**NOTICE OF MEETING**

**Planning and Environment Committee Meeting No. 1/14**

<b>Item</b>	<b>Page</b>
1 CONFIRMATION OF MINUTES - Meeting held on 3 December 2013 .....	1
2 20 AMIENS STREET, GLADESVILLE - LOT A DP 27326. Development Application for demolition and construction of a new part 2 / part 3 storey dwelling, pool, front fence and landscaping. LDA2013/0211 .....	7
3 78-80 WINBOURNE STREET EAST, WEST RYDE. LOT 19 & 20 DP 28855. Multi dwelling housing: 6 units - 2 x two storey units at the front (1 x 3 and 1 x 4 bedroom) and 4 x single storey 3 bedroom units at the rear & strata subdivision - LDA2013/0222.....	111
4 94 ADELAIDE STREET, MEADOWBANK. LOT 5 DP 9072. Local Development Application for a new 1.5m high front fence and retaining walls. LDA2013/0391. ....	155

**Roof Plan showing extent of 3 storey component**

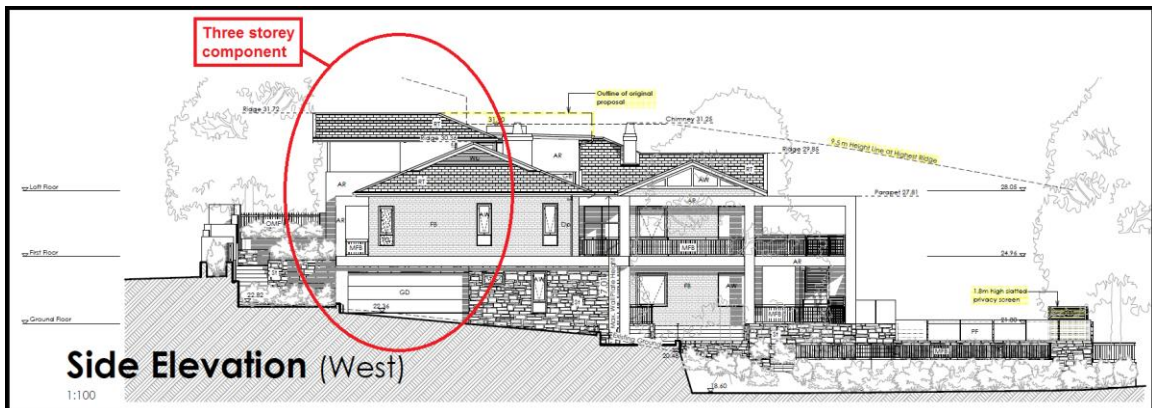
*Concerns are raised over the three storey component of the proposed development.*

The extent of the three-storey component in this development is shown in the following drawings (roof plan and west elevation):

The following drawing (section A) shows the location and extent of cut and fill associated with the proposal.

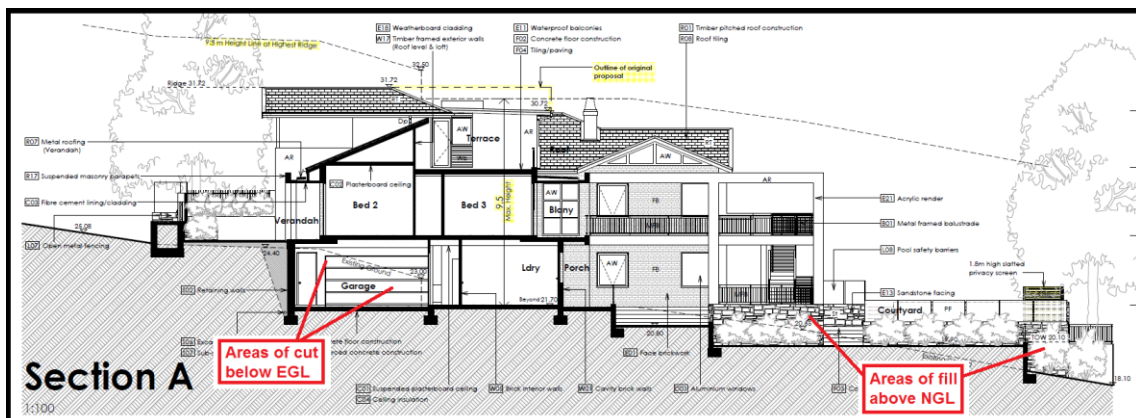
Given the above, the proposed non-compliance with the topography and excavation controls contained within the Ryde DCP 2010 are considered justifiable in this instance, particularly as the provisions of Section 79C(3A)(b) the Environmental Planning and Assessment Act 1979 as noted above.

Diagram indicating the proposed 1.8m high 'L' shaped privacy screen to be installed adjacent to the area where the pool coping height extends significantly beyond the maximum amount permitted and where potential for overlooking of neighbouring property could have occurred.

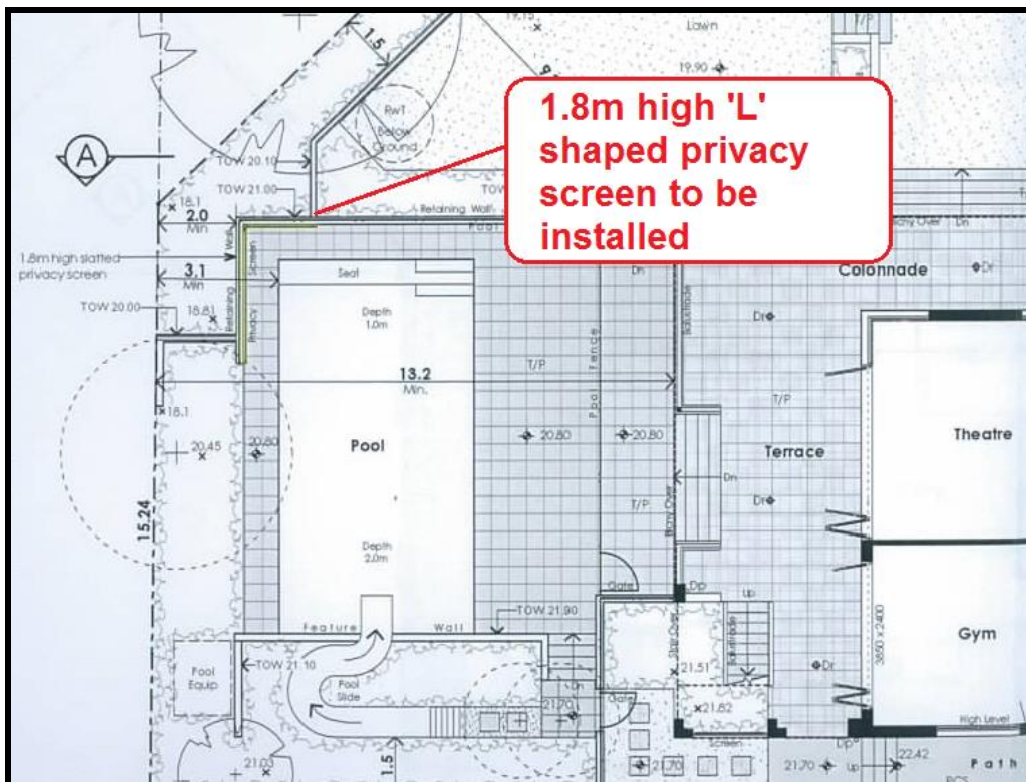
*Concerns have been raised from the adjoining property at 7 Pile Street with regard to the height of the proposed swimming pool relative to the property and lack of mitigating measures.*

As such a request for additional information, along with subsequent meetings with the applicant brought about changes to the proposed design which now include the installation of a 1.8m high 'L' shaped privacy screen to the coping of the swimming pool to ensure privacy is maintained to adjoining properties to the south via reduced opportunities for overlooking, as shown in the following drawing:

Accordingly, based on the outcomes the design modifications to include the privacy screen to the swimming pool, it is considered that the privacy impacts raised from 7 Pile Street have been adequately addressed in the amended plans.

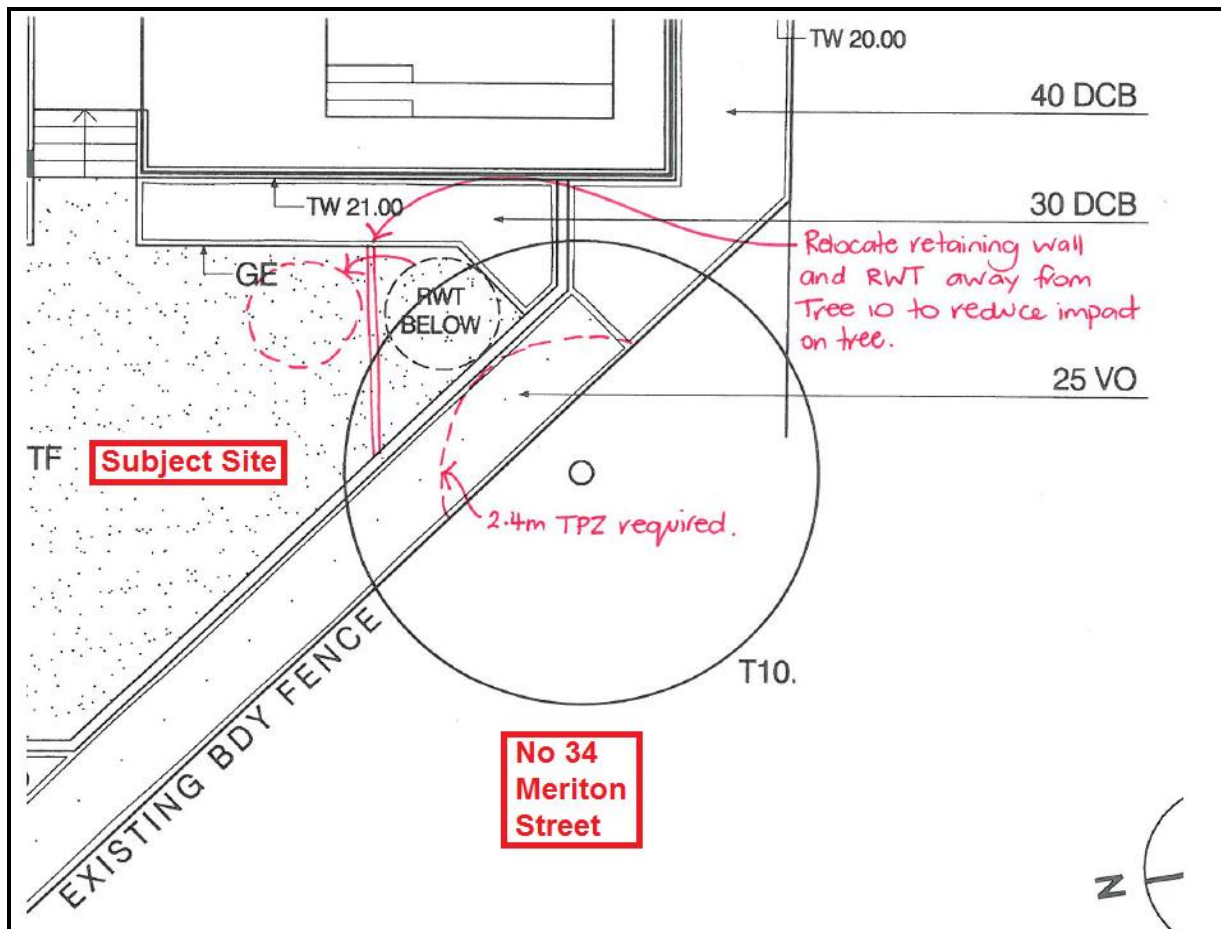
*The *Glochidion ferdinandi* (Cheese Tree) located on the adjoining property at 34 Meriton Street is to be retained and protected as part of the proposed development through establishment of a 2.4m Tree Protection Zone (TPZ).*

*In this regard, to ensure adequate protection of the tree's roots, the proposed rainwater tank and retaining wall adjacent to the rainwater tank is to be relocated away from the 2.4m tree protection zone area. Details of the revised rainwater tank and retaining wall location are to be submitted to Council for approval prior to the issue of the **Construction Certificate**.*

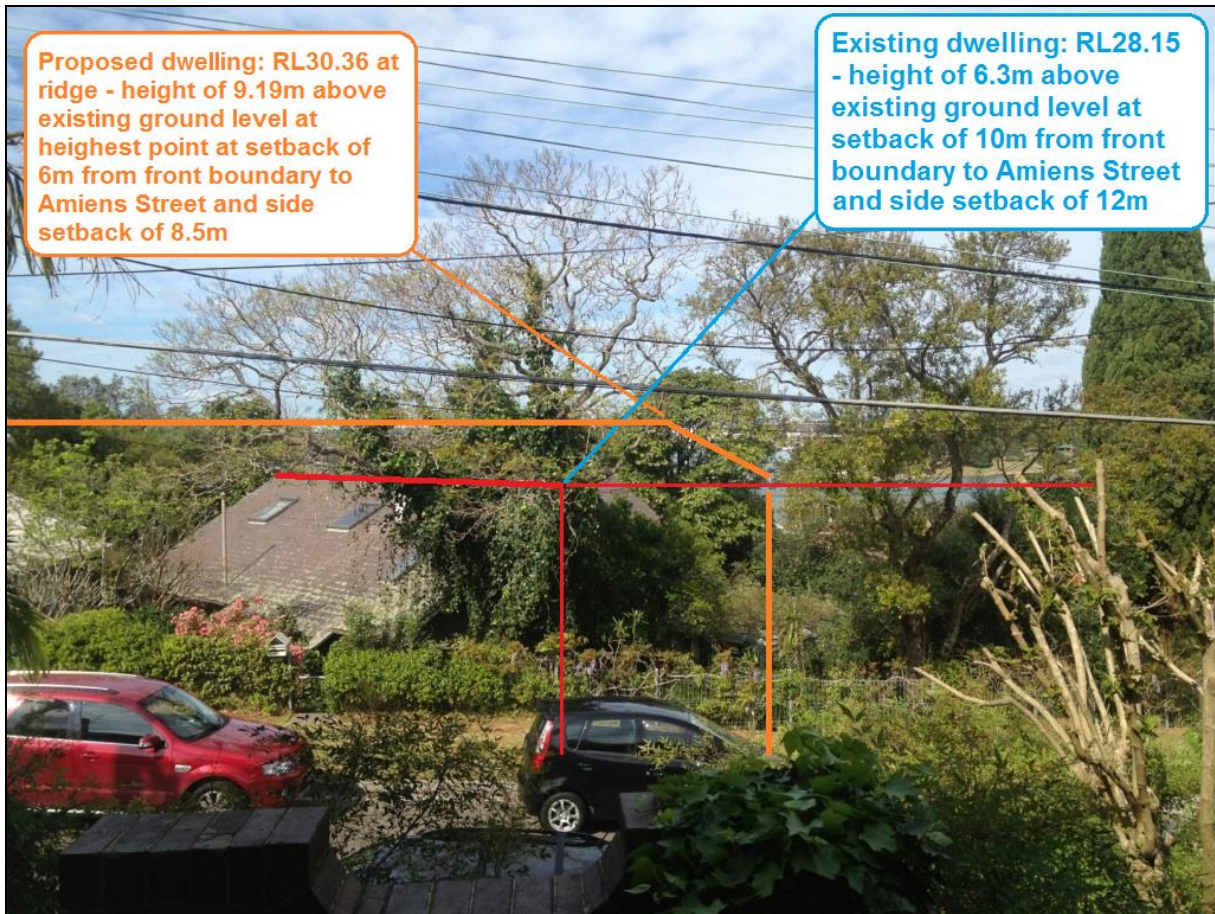
As evident in **Figure 23**, the anticipated view loss from the front porches of the dwelling houses on the northern side of Amiens Street is considered to range from being minor or more significant depending on the particular dwelling house, view orientation and level of vegetation / development obscuring the view.

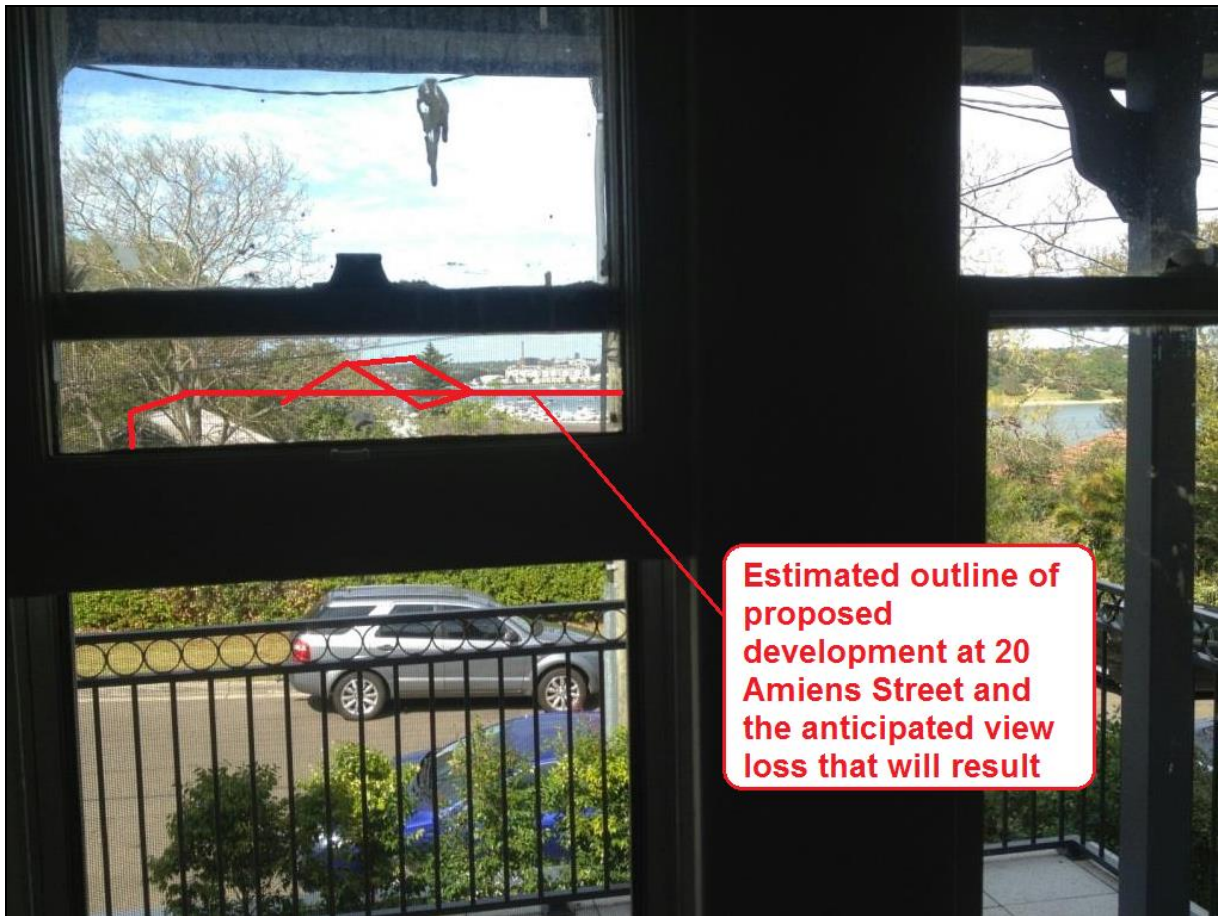
As evident from **Figure 25**, the anticipated view loss is considered to be moderate to significant, as although a larger portion of view loss is experienced to the south and south east, views are retained to the south-west where the intersection of Amiens Street and Meriton Street provide some relief in vegetation and development to present some small views over Parramatta River.

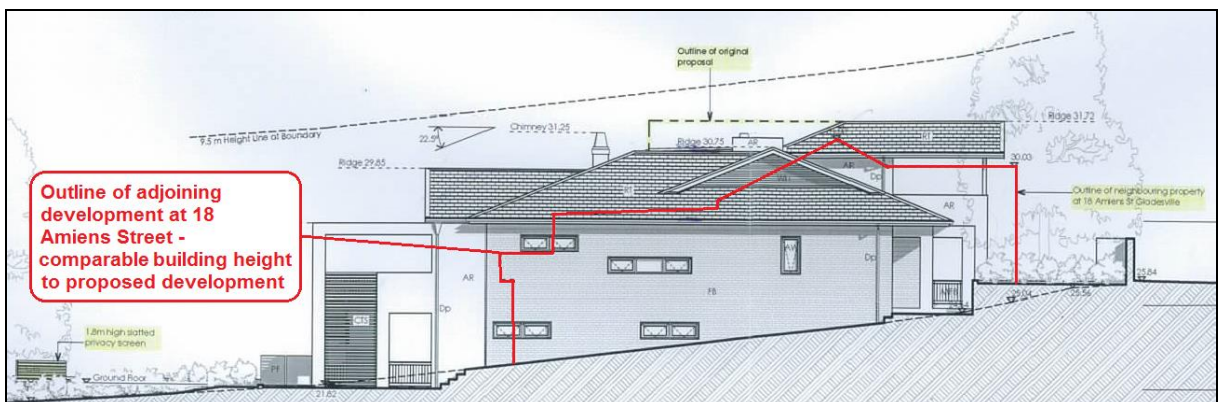
**Figure 26** demonstrates that the height of the proposed development is somewhat comparable to that of the adjoining development at 18 Amiens Street.

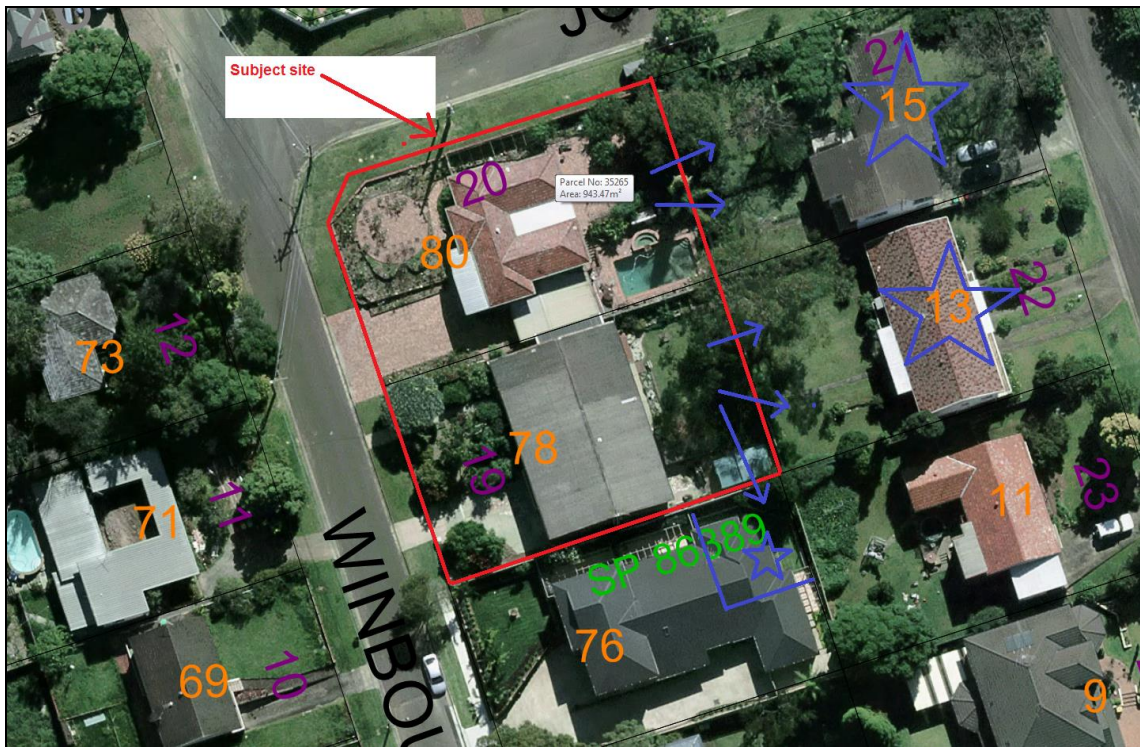
Concern is raised that due to the natural cross fall of the site, the courtyards (despite not being filled) and terrace levels of units 3 and 4 would permit overlooking into the neighbouring properties, which in this case, consists of 3 properties (No 13 and 15 Lambert Avenue and the rear unit within 76 Winbourne Street). The aerial photo below shows the affected properties marked with a blue star and the arrows indicating the direction of overlooking.

The elevated terrace of unit 3 is within 1.7m of the boundary and up 1.15m above NGL and will overlook 15 Lambert Street. The elevated terrace of unit 4 is within 1.1m of the rear boundary and up to 350mm above natural ground level (NGL) and will overlook 13 Lambert Street. However, when looking south from the terrace (of unit 4) towards the southern side boundary, overlooking of the courtyard unit within 76 Winbourne Street (of unit 3 in that development) will occur. The height of natural ground level at the side boundary is 1400mm lower than the terrace of unit 4.

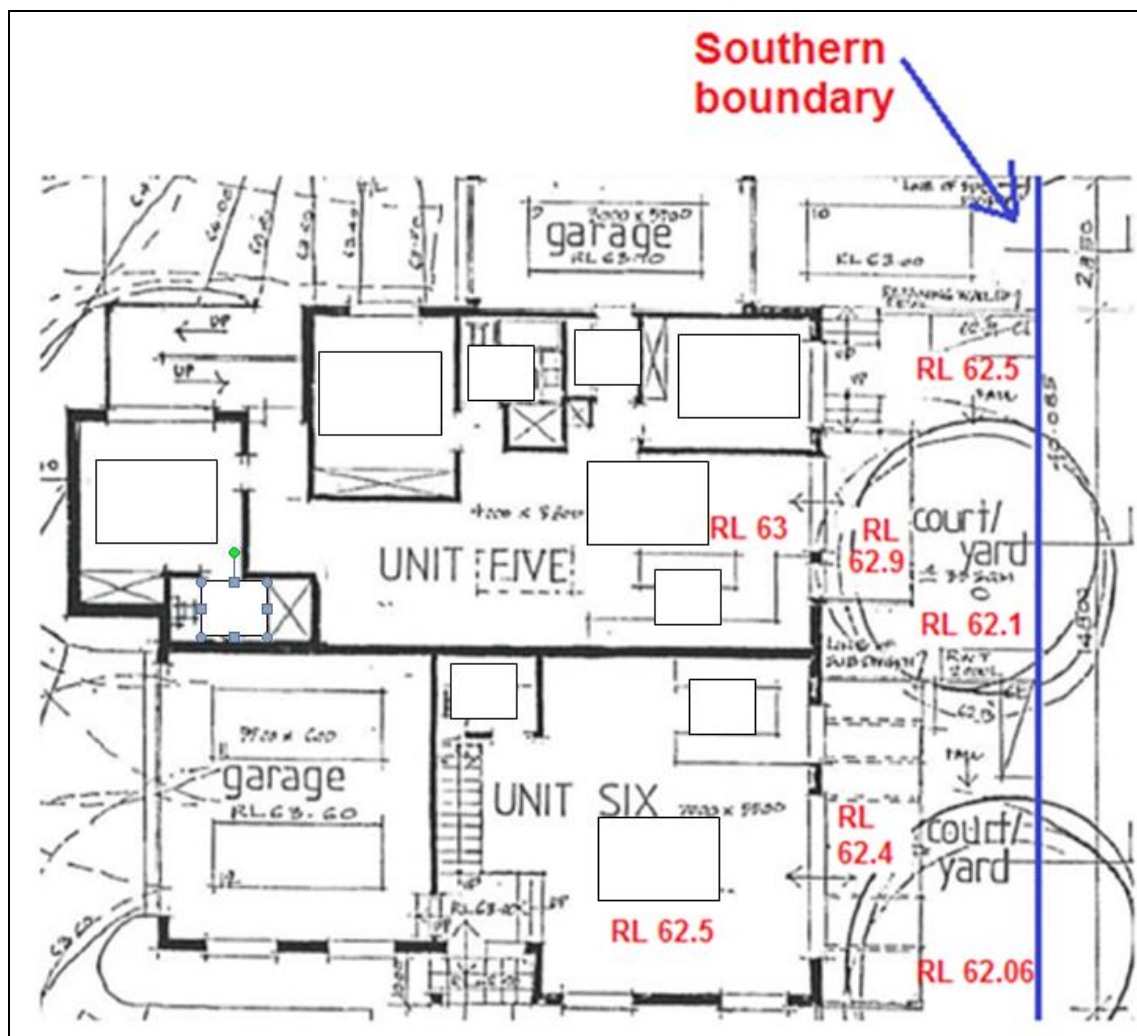
Courtyards and terraces associated with units 5 and 6 are located along the southern side boundary, adjoining 76 Winbourne Street.

An extract of the DA site plan, showing the site levels in the courtyards and terraces for these units, appears below:
